# PLANNING COMMISSION MEETING AGENDA REGULAR MEETING

May 24, 2022 7:00 P.M. Council Chambers

PRELIMINARY SITE PLAN APPROVAL (File Number SP2019-0041) – Proposed Lange View Estates, East of Crooks Road, Southeast corner of Livernois and Leetonia (4080 Livernois), Section 15, Currently Zoned NN Neighborhood Node (Node "H") District.

#### Site Plan Review For City of Troy, Michigan

Sheet Title:
Unit "A" Floor
Plans

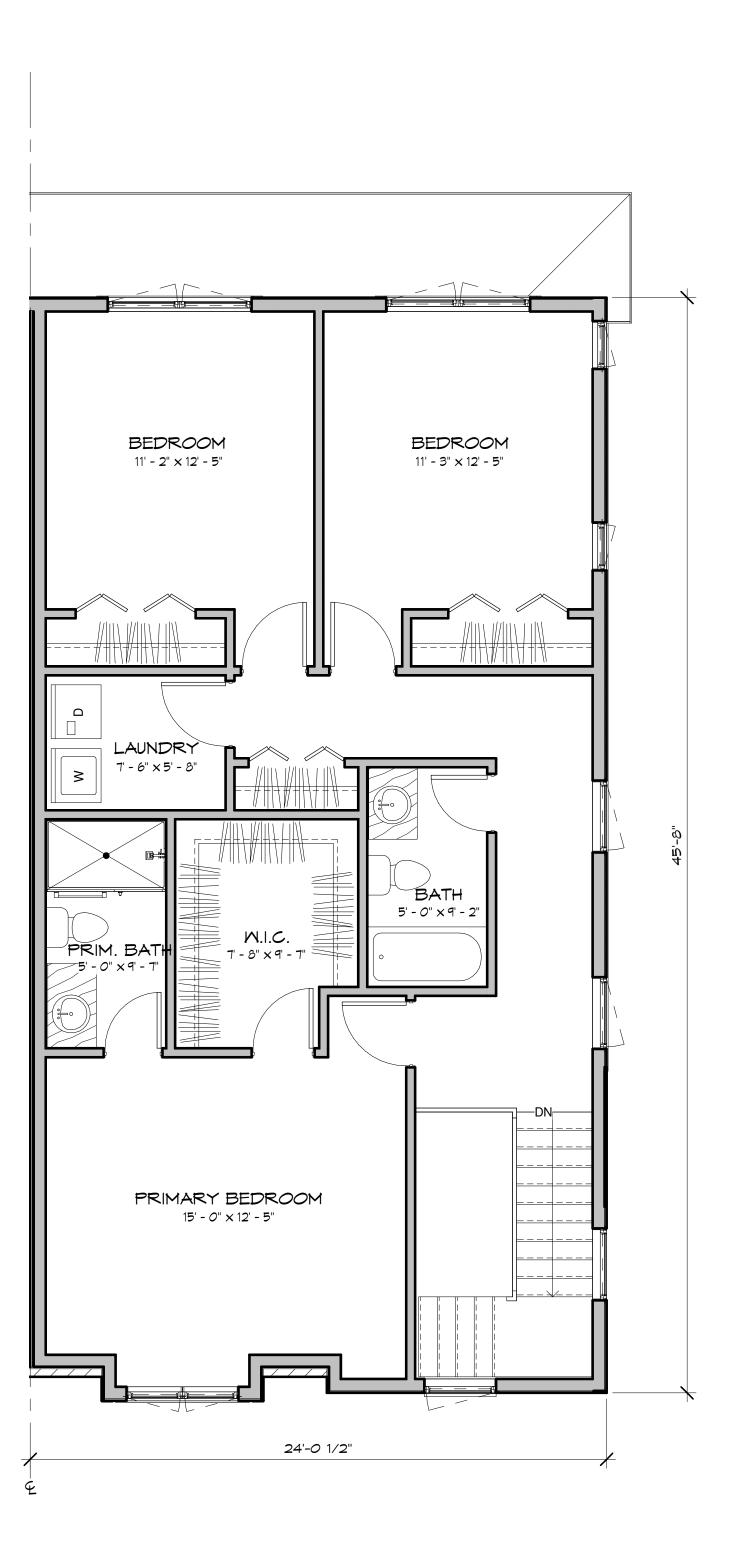
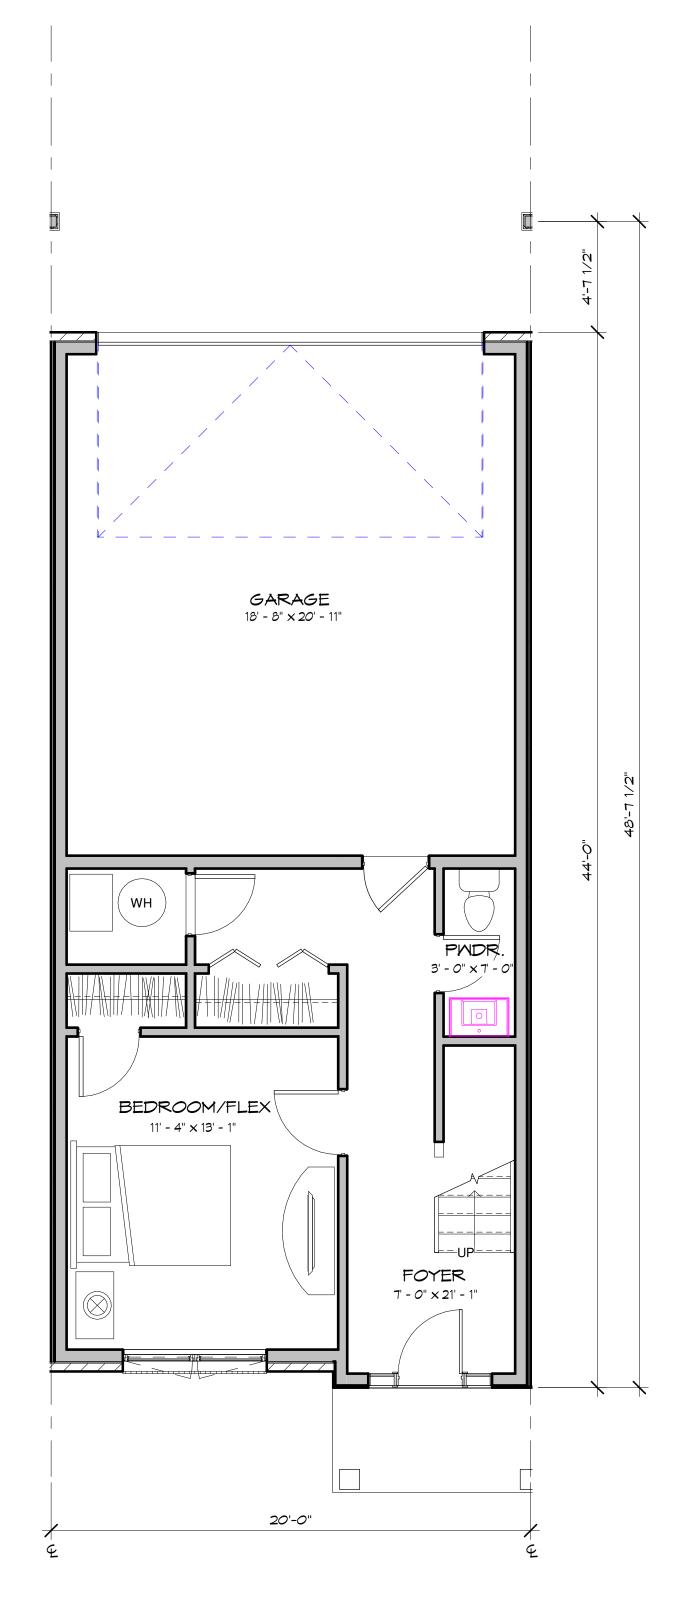
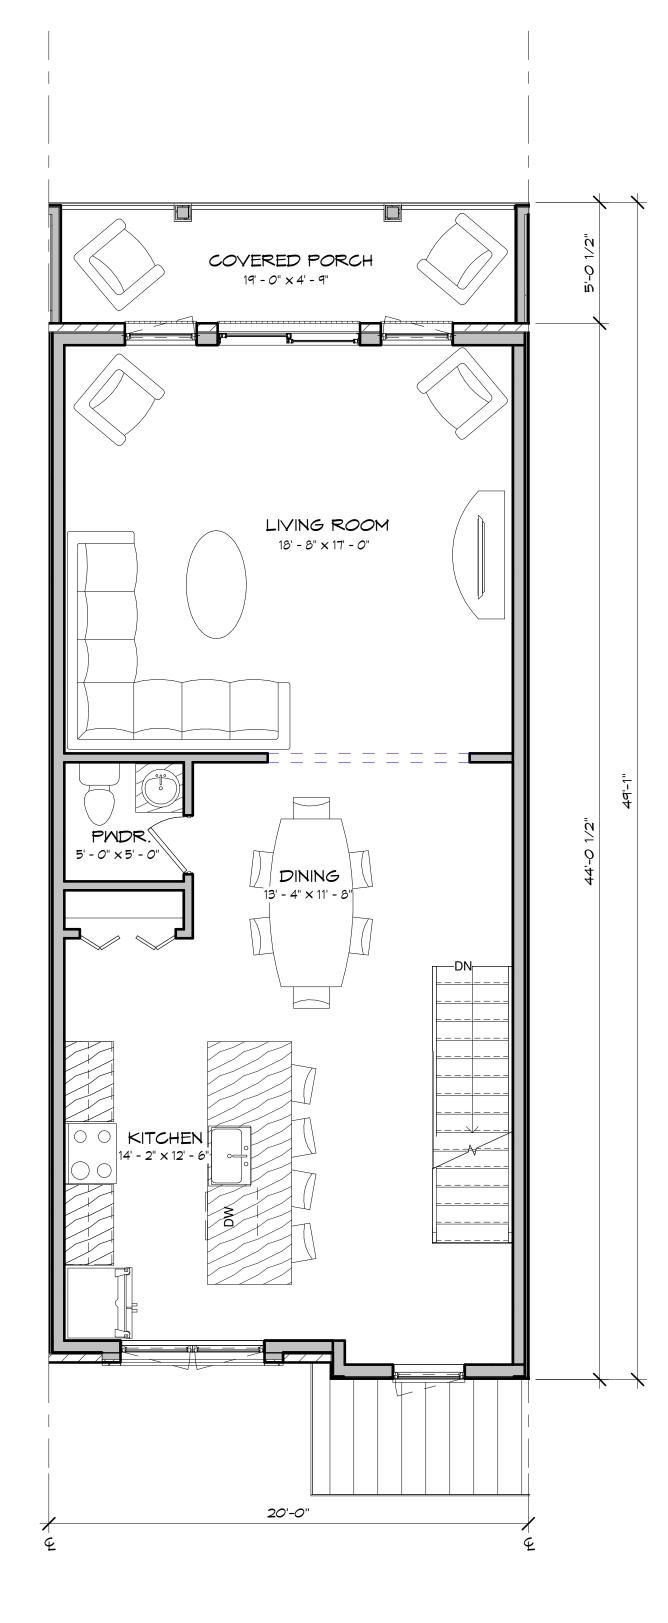
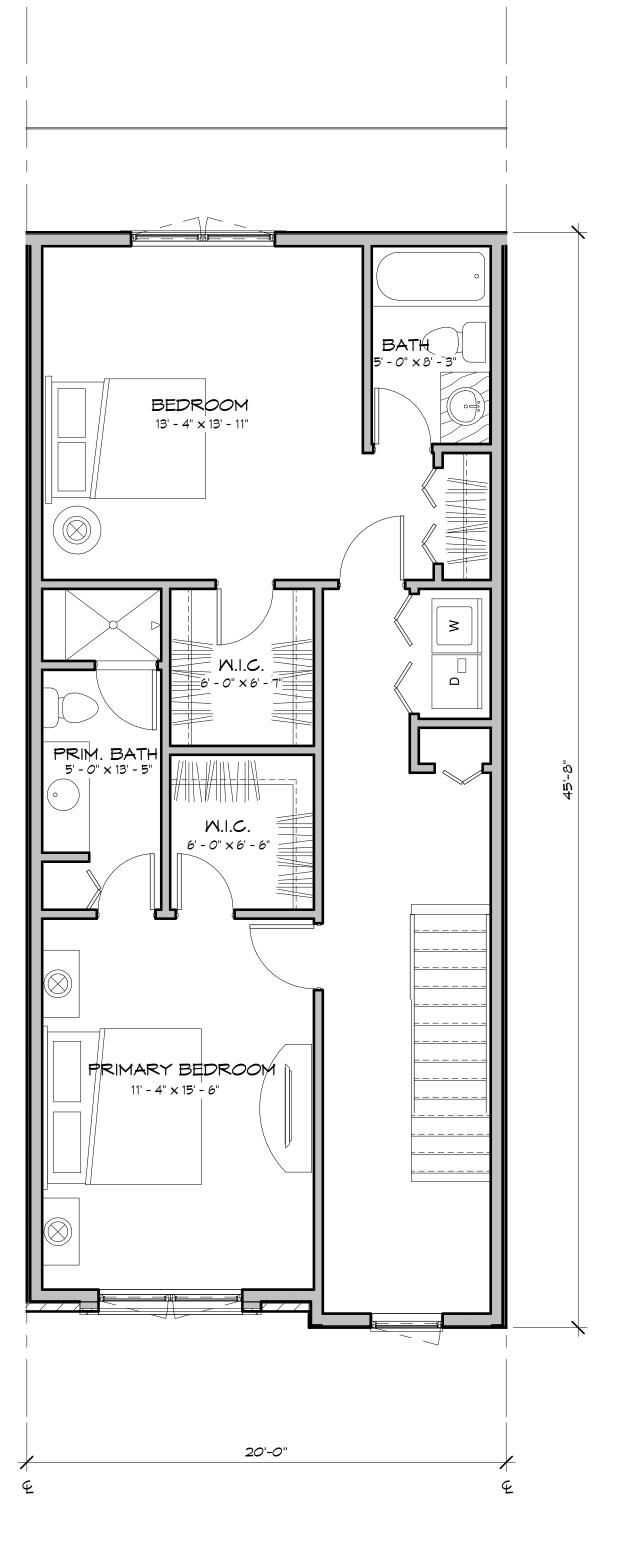
#### FLOOR PLAN AND ELEVATIONS

Floor plans and elevations have been provided on pages A1, A2, A3, and A4. The elevations show architectural details, variations in material and pattern. Elevation maximum details were provided on page A3 however, there was no indication of the elevation transition from west to east that was discussed at the February 23, 2021 City of Troy Planning Commission Meeting. The photo below shows the area of the site of the proposed townhome in relation to adjacent buildings.

**Items to be Addressed:** Provide elevation details regarding transition.
